Job Stamp	
04-0120F4	
SFOBB SAS

ASSISTANT RESIDENT ENGINEER'S CONTRACTOR – ABFJV, Sub RPS

Description of Operations @ W2 Cap Beam:

File Name:	July-02-2008 W2 Cap 005
Date:	07-02-08
By Int:	M Bruce

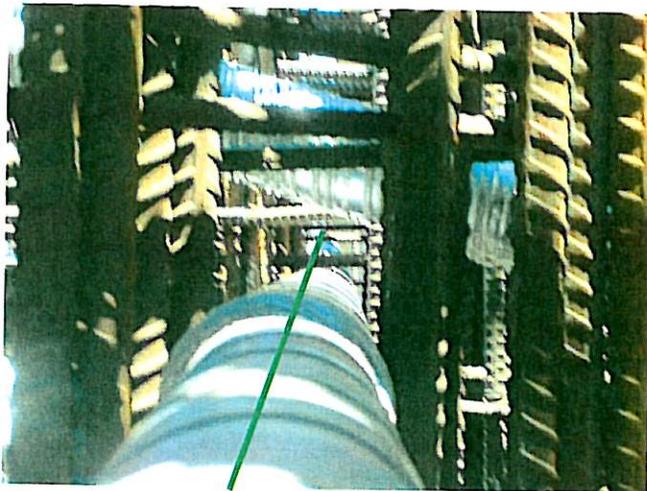
- a) Continuity tendons E-30B through E-37B need to be straightened out, see photo below.
 - b) There needs to be adequate spacing (25mm minimum) between E-30B and the transverse tendons directly underneath, see photo below. I suggested placing a 25mm dobbie in between the tendons and tying both ducts together.

Description: Per the Special Provisions section 20-1.42 under "Ducts" the minimum clear spacing is 25mm between ducts. The continuity tendon shown is E-30B with the strong pipe above. The photo taken above is typical of the clearance between E-30B and the transverse tendons through the W2E column cages.
